ADDENDUM NO. 1
Penguin Life Support System Upgrade
REQUEST FOR BIDS #11-1717
August 11, 2010

THE FOLLOWING ARE CHANGES TO THE CONTRACT DOCUMENTS

SHEET NO.: RA02
REFERENCE SHEET NO.: A2.1

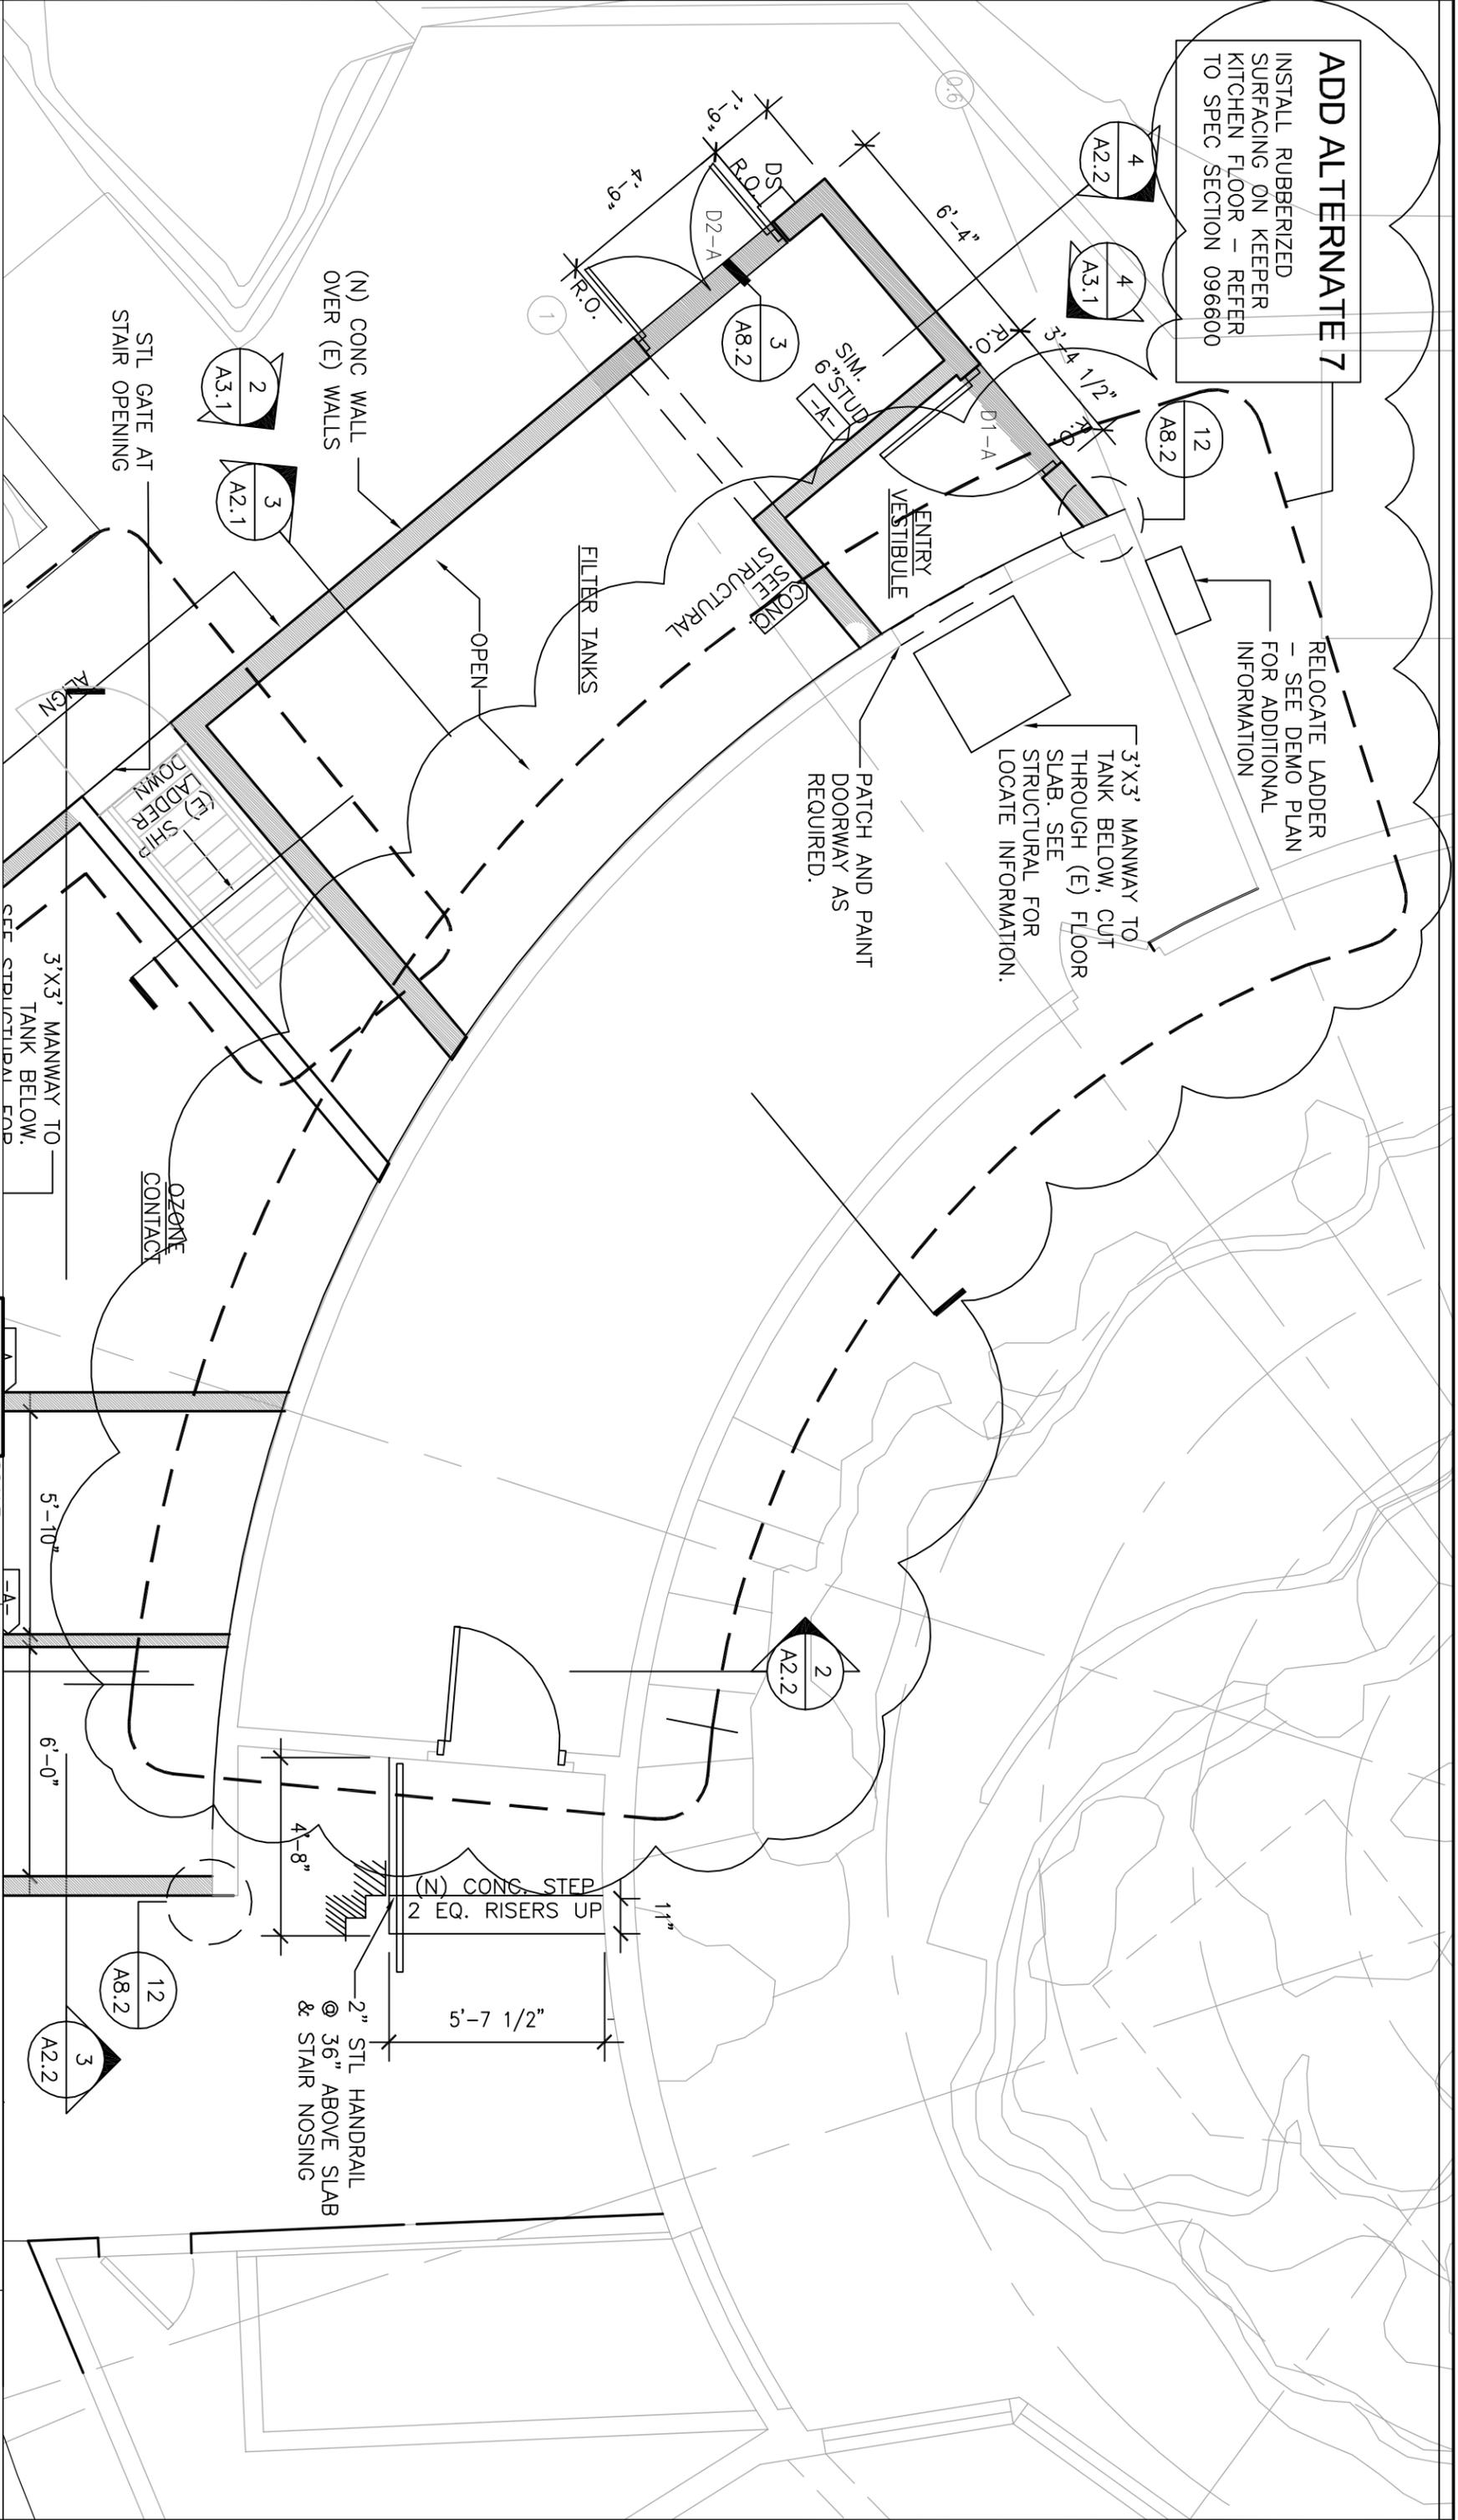
- B. DRAWING RA02 NAME: A2.1 ARCHITECTURAL PLANS, REVISION MADE:
1. 2/A2.1 - ADD detail bubble and tag with note to read:

"ADD ALTERNATE 7
INSTALL RUBBERIZED FLOOR SURFACING ON KEEPER KITCHEN FLOOR - REFER TO
SPEC SECTION 096600"
- C. DRAWING RM.01 NAME: 2/M2.1 Mechanical - Main Floor Plan, REVISION MADE:

ADD ALTERNATE 7
INSTALL RUBBERIZED SURFACING ON KEEPER KITCHEN FLOOR - REFER TO SPEC SECTION 096600

SHEET NO.:
RM.01
REFERENCE SHEET NO.:
2/M2.1

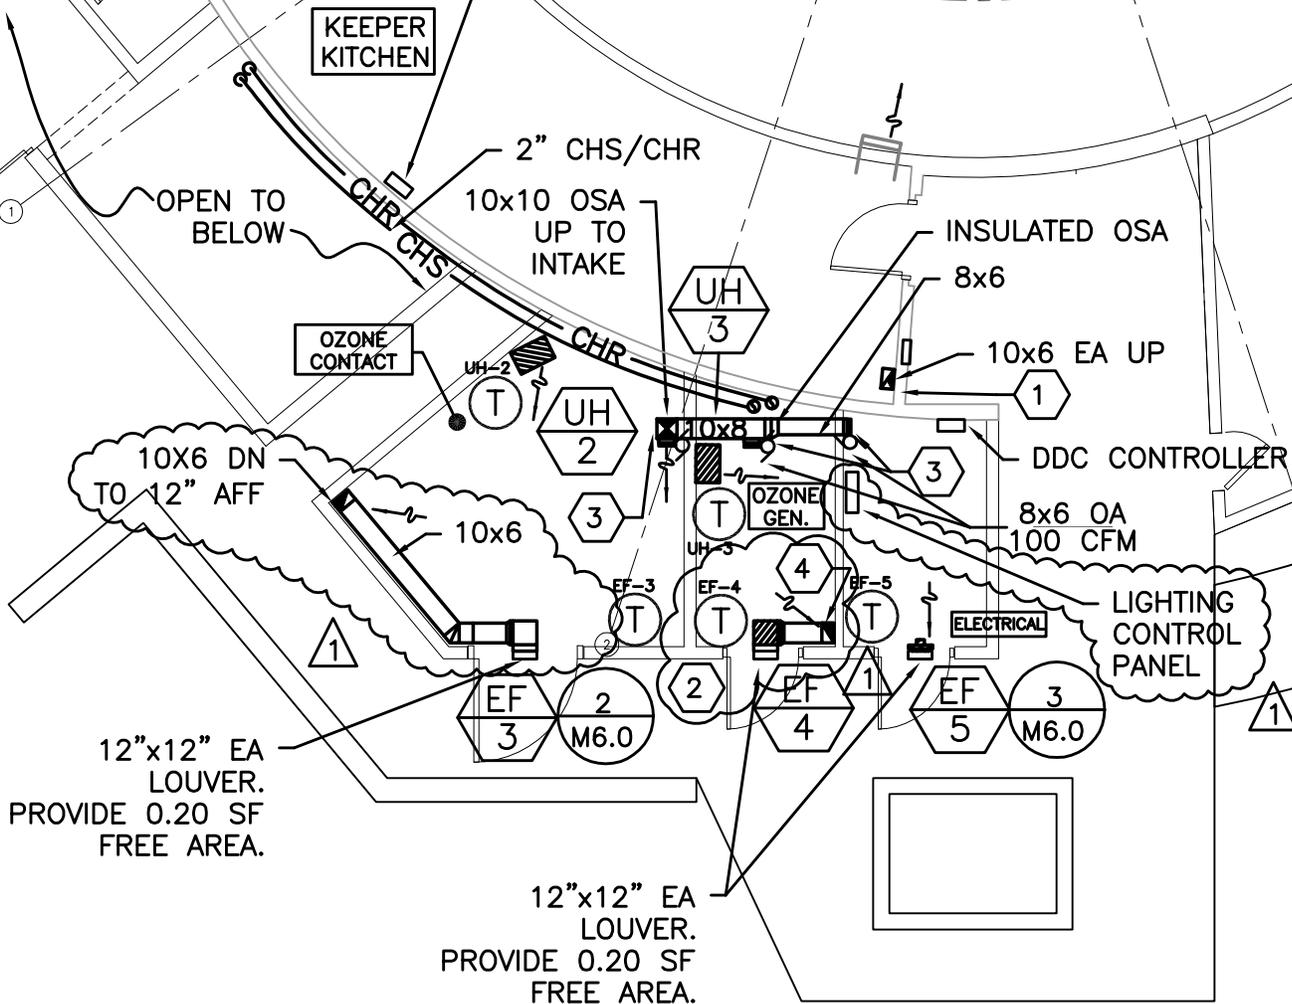
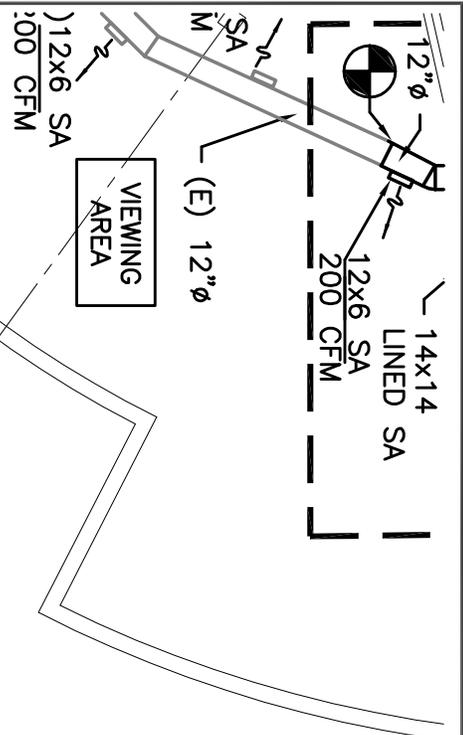
DDC CONTROL POINTS CONNECT TO CENTRAL SYSTEM

POINT DESCRIPTION	INPUT		OUTPUT		ALAI
	DIGITAL	ANALOG	DIGITAL	ANALOG	
OZONE LEVEL*		X			
OZONE HIGH LEVEL ALARM*	X				X
OZONE LOW LEVEL ALARM*	X				X

*CONNECT TO OZONE UNIT IN OZONE GENERATOR ROOM.

- 1) INTEGRATE LIGHTING CONTROL PANEL, SEE SPECS.
- 2) PROVIDE CONTROL OF DEVICES AND SYSTEMS PER SPEC SECTION 22 55 00.

SHEET NO.: RM.02
REFERENCE SHEET NO.: 2/M2.1

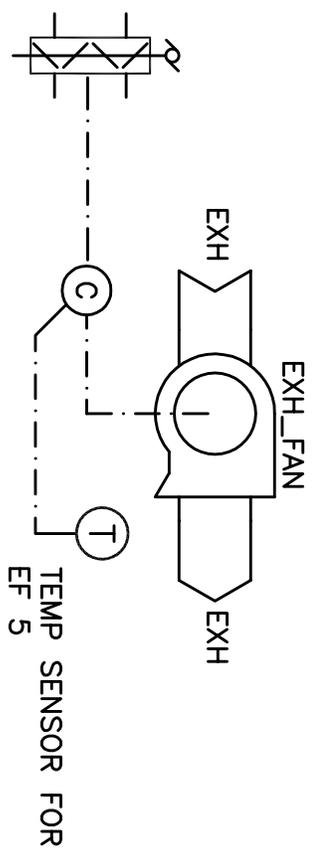
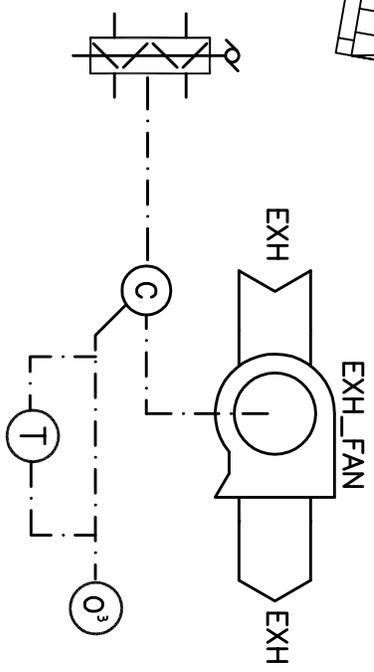
1. ROUTE EXHAUST DUCTWORK IN (E) OPENING OF FLOOR GRILLE, PROVIDE PATCH AS REQUIRED TO CLOSE OFF REMAINDER OF EXISTING OPENING.
2. EXHAUST FANS 'EF-3' & 'EF-4' TO BE CONTROLLED BY OZONE GENERATOR ALARM SIGNAL.
3. PROVIDE 120 V TWO-POSITION CONTROL DAMPER FOR OPERATION WITH EXHAUST FANS EF-3, EF-4 & EF-5.
4. 10x6 EA DUCT DN. PROVIDE EXHAUST AIR OPENING @ 12" AFF.

6 EF-5 CONTROL DIAGRAM
SCALE: SCHEMATIC

7 EF 3&4 CONTROL DIAGRAM
SCALE: SCHEMATIC

SHEET NO.:
RM.03
REFERENCE SHEET NO.:
M6.0

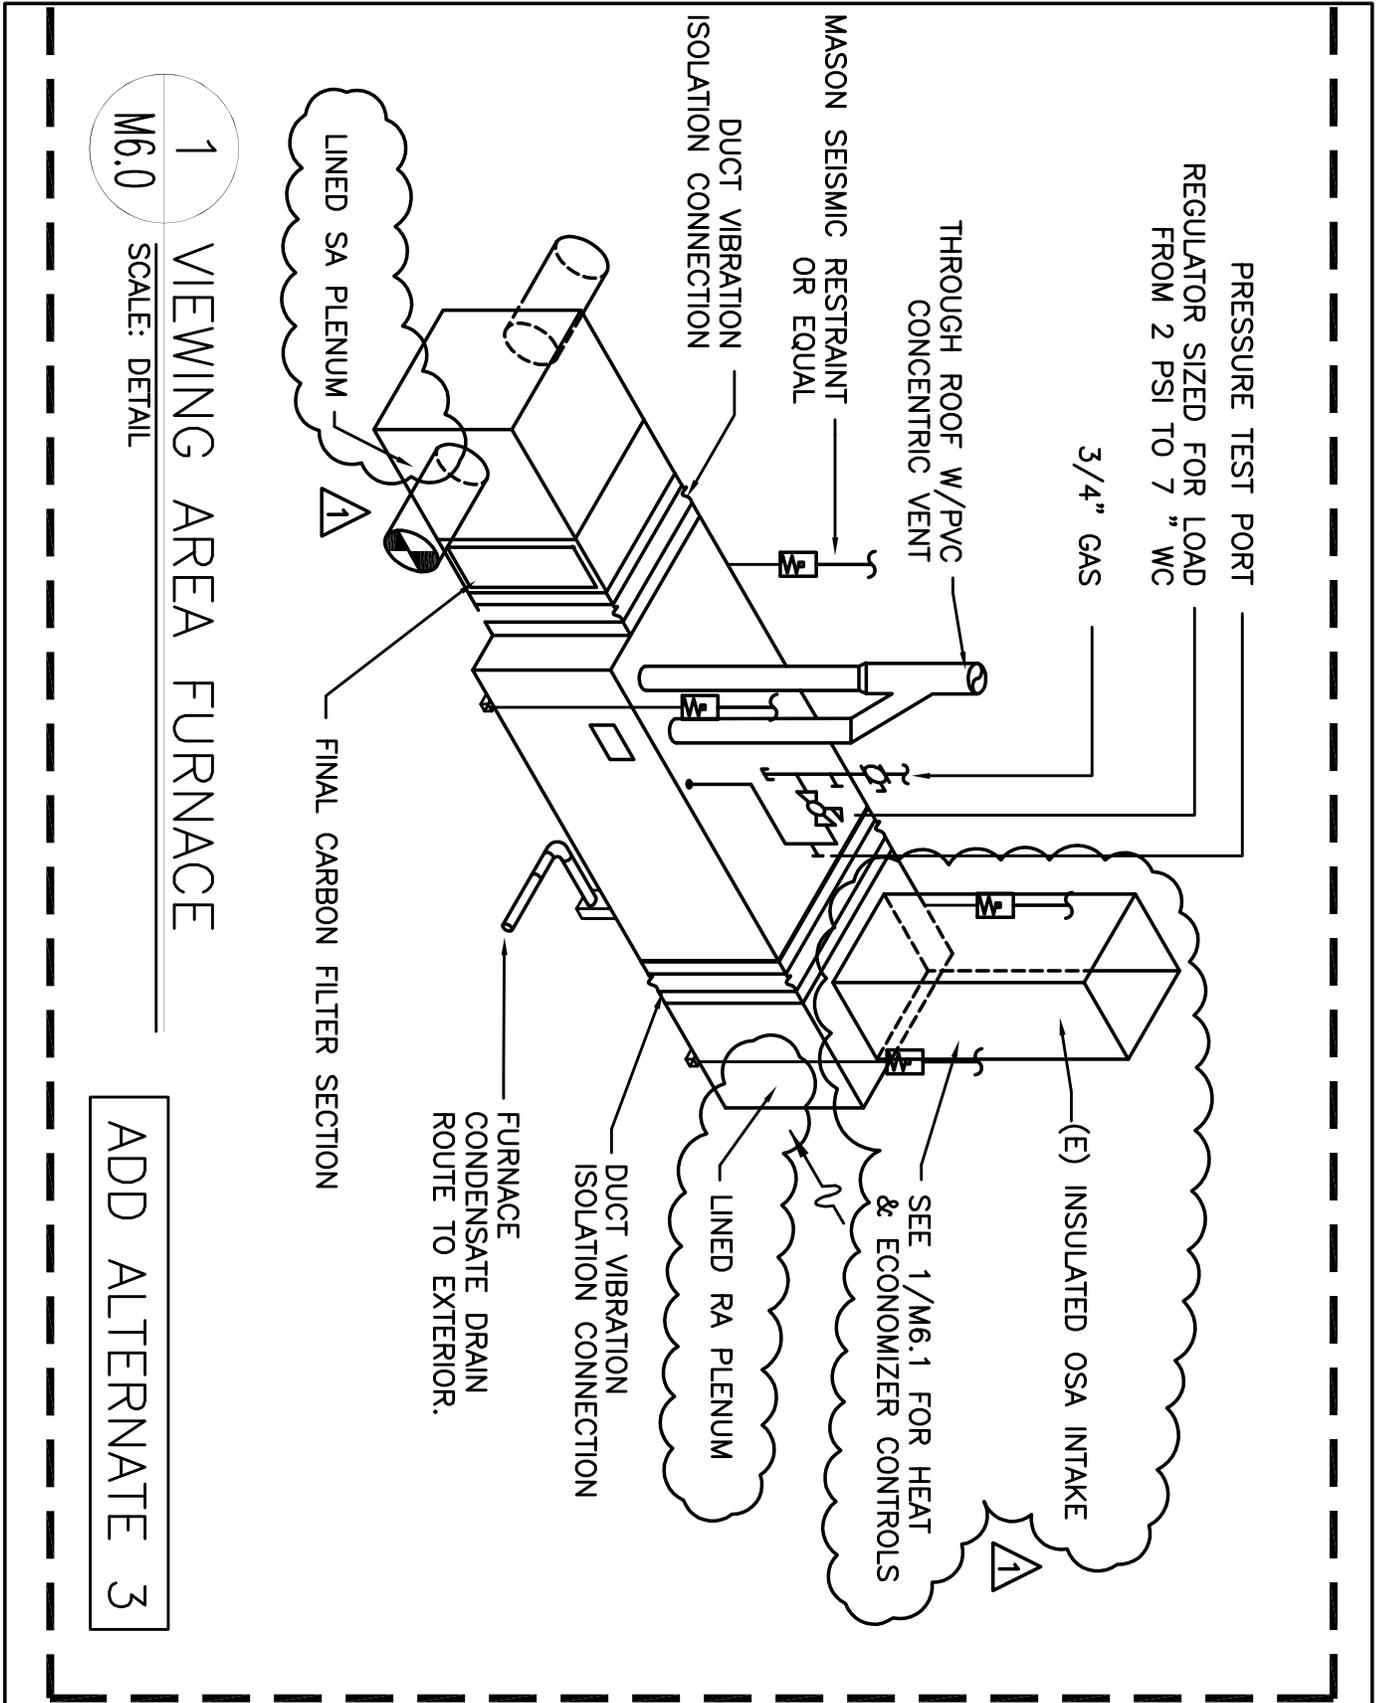
1. As shown to mechanical schedules on drawing.
- F. DRAWING RM.04 NAME: M6.0 Mechanical Legend, Schedule & Details, REVISION MADE:
1. As shown on drawing.

WATER TO WATER HEAT EXCHANGER		
MARK NUMBER		
TYPE	 PLATE & FRAME DOUBLE WALL	
COLD SIDE	GPM	35
	ENT. WATER (° F)	42
	LVG. WATER (° F)	52
	MAX PRESS DROP (PSI)	2.5
	% GLYCOL	25%
HOT SIDE	GPM	280
	ENT. WATER (° F)	55
	LVG. WATER (° F)	53.75
	MAX PRESS DROP (PSI)	13.5
	% GLYCOL	 -
MIN HEATING SURFACE (SQ.FT)	180	
FOULING FACTOR	-	
DESIGN WEIGHT (LBS)	1150	
NO. OF PLATES	114/147	
CAPACITY	176 MBH/h

EXHAUST FAN	
MARK NUMBER	
TYPE	CABINET
CFM	1700
TOTAL SP. (IN H2O)	0.75
RPM	1725
MOTOR HP	3/4
VOLTAGE/HZ PHASE	115/60/1
INTERLOCK WITH	F-1&F-2
BACK DRAFT DAMPER	YES*
DESIGN WEIGHT (LBS)	265
MAX. SONES	10.0
BASIS OF DESIGN	GREENHECK BC

EXHAUST FANS					
MARK NUMBER					
TYPE	SIDEWALL	IN-LINE	IN-LINE	IN-LINE	
CFM	125	125	200	125	
TOTAL SP. (IN H2O)	0.25	.35	0.25	0.25	
RPM	1050 *	1050 *	1050 *	1050 *	
MOTOR HP	1/30	50 WATTS	1/30	1/30	
VOLTAGE/HZ PHASE	115/60/1	115/60/1	115/60/1	115/60/1	1
CONTROLLED BY	TIME CLOCK	TIME CLOCK	OZONE ALARM	OZONE ALARM	TEM
INTERLOCK WITH	OSA DAMPER	OSA DAMPER	-	OZONE GEN.	
BACK DRAFT DAMPER	YES	YES	YES	YES	
ISOLATION	-	YES	-	-	
DESIGN WEIGHT (LBS)	15	15	15	15

<p>Kpft Consulting Engineers 70 SW Palm Avenue Portland, Oregon 97204 (503) 227-4551 STRUCT. FAX (503) 227-7889 OHL FAX (503) 227-4891</p>	SCALE: NTS	TITLE:	SHEET NO.:
	JOB NO.: 309265	PROJECT: PENGUIN LIFE SUPPORT SYSTEM UPGRADE OREGON ZOO	ADDENDUM#-1
DATE: 08/10/2010			REFERENCE SHEET NO.: 5/M6.0

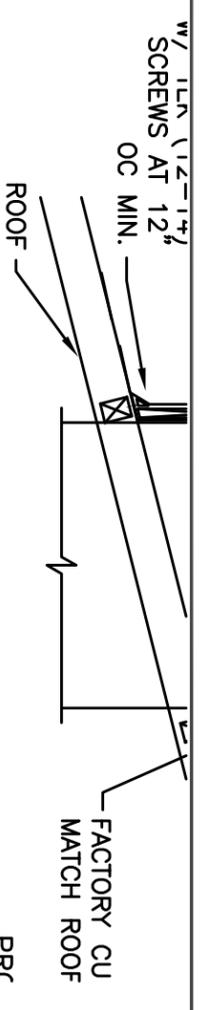
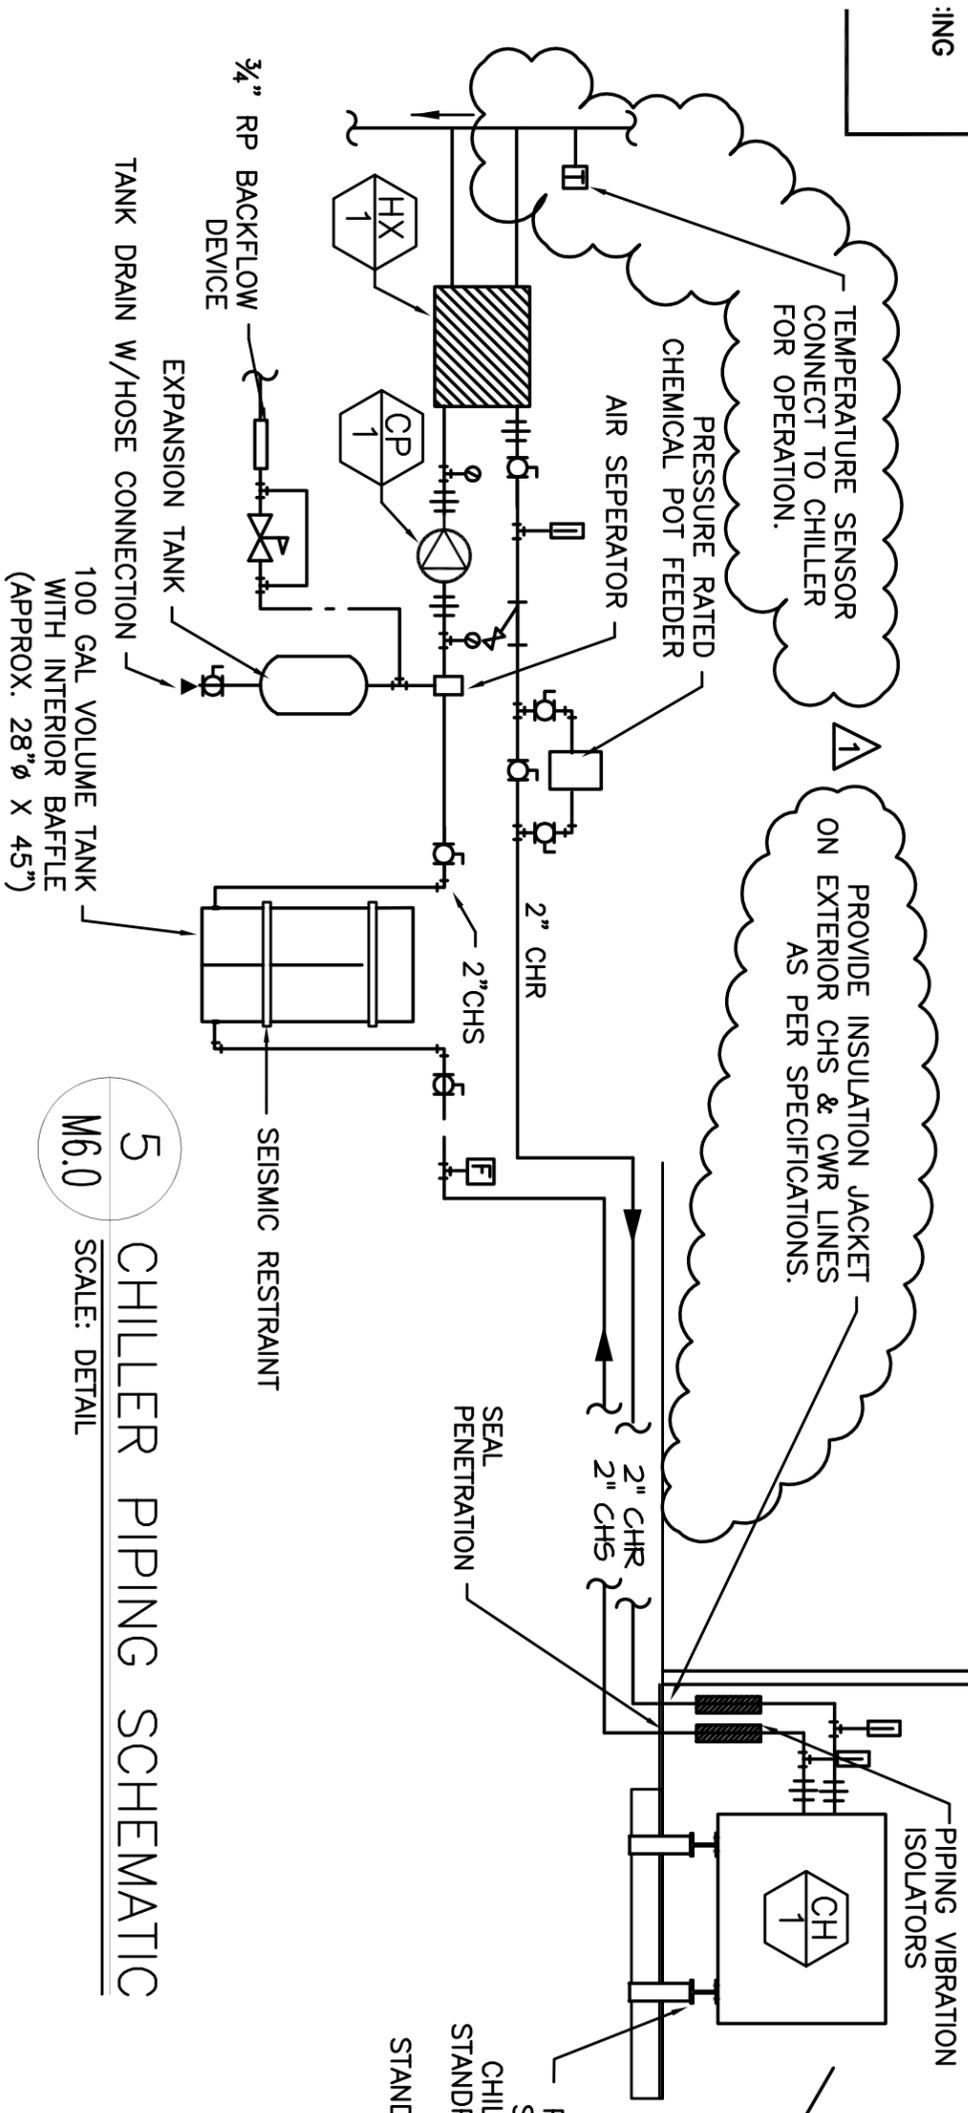
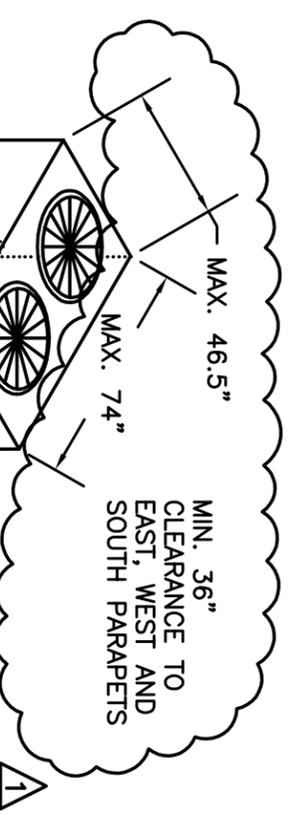
5 CHILLER PIPING SCHEMATIC
SCALE: DETAIL
M6.0

PROVIDE STRUCTURAL STEEL FOR MOUNTING CHILLER TO STRUCTURAL STANDPIPES. FASTEN STEEL TO CHILLER AND STANDPIPES AS REQUIRED.
